Product: MARINE ENGINE  
 Model: C18 MARINE ENGINE CYN  
 Configuration: C18 Marine Auxiliary Generator Set CYN00001-UP

### Engine News

## A New Oil Pan Gasket Is Used for Certain C18 Marine Engines, and Available for Certain 3406E and C15 and C18 Marine Engines {1302, 7555}

Illustration 1

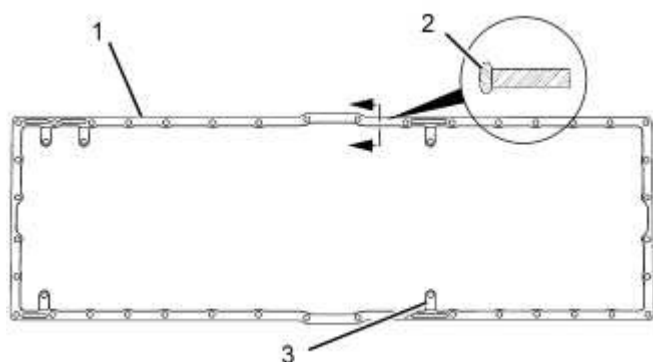
A new one piece gasket for the engine oil pan is used on certain C18 Marine Engines. Also, the new gasket has the following features, which are shown in Illustration 1. The new gasket helps to eliminate oil leaks.

**Adaptable To:** The gasket is adaptable back to the first production of the engine. The **345-0412** Gasket is a direct replacement for the **188-0210** Gasket.

The change is effective at the factory with the engine serial number JKX00265-UP.

**Note:** The **345-0412** Gasket is also available for the following Marine Engines that are listed in the serial number's list: 3406E, C15 and C18. The **345-0412** Gasket can replace the **4N-1151** Gasket or the **4N-3661** Oil Pan Gasket.
